State of New Mexico
Energy, Minerals and Natural Resources

Form C-103
Revised July 18, 2013

WELL API NO.
30-005-60992

7. Lease Name or Unit Agreement Name
Eastland State

Current Wellbore Diagram

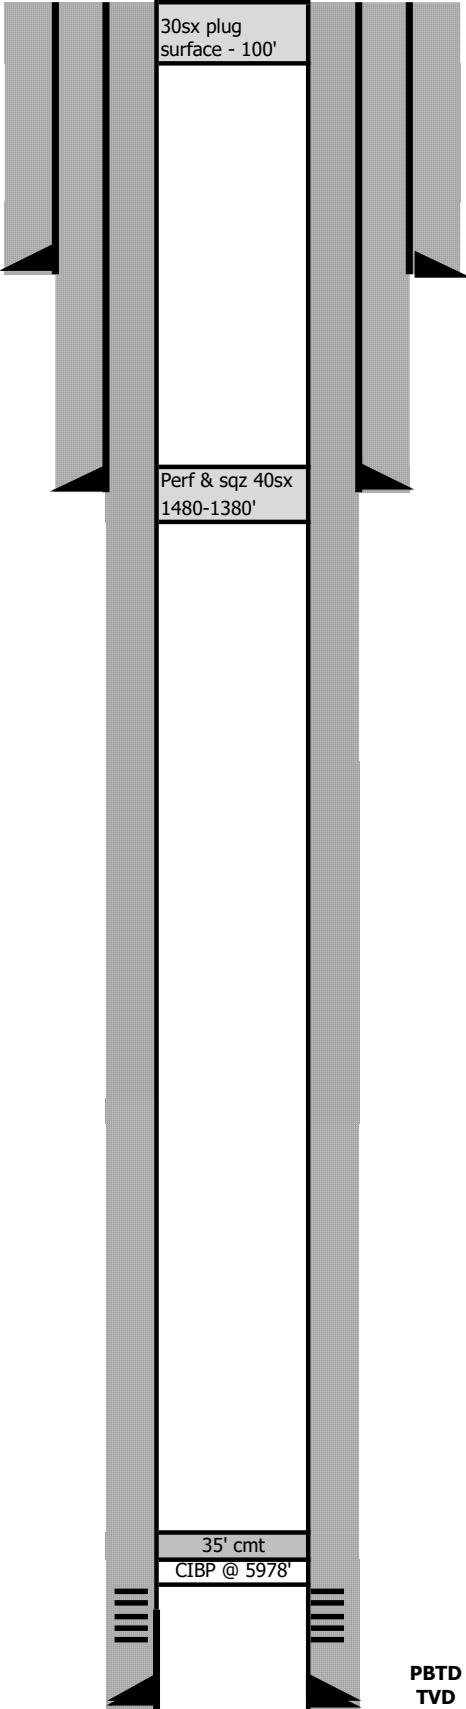
Created By	Condition	Condition Date
loren.diede	Notify NMOCD 24 hours prior to beginning P&A operations.	9/30/2024
loren.diede	Run CBL from 5978' to surface.	9/30/2024
loren.diede	Submit CBL tif file into NMOCD Imaging via Electronic Permitting.	9/30/2024
loren.diede	Add a plug of 25 sx from 5288' to 5138' to cover the Wolf Camp formation top.	9/30/2024
loren.diede	Add a plug of 25 sx from 4810' to 4660' to cover the Abo formation top.	9/30/2024
loren.diede	Submit P&A marker photo and GPS coordinates with the subsequent P&A report. P&A marker is to be an above-ground marker.	9/30/2024
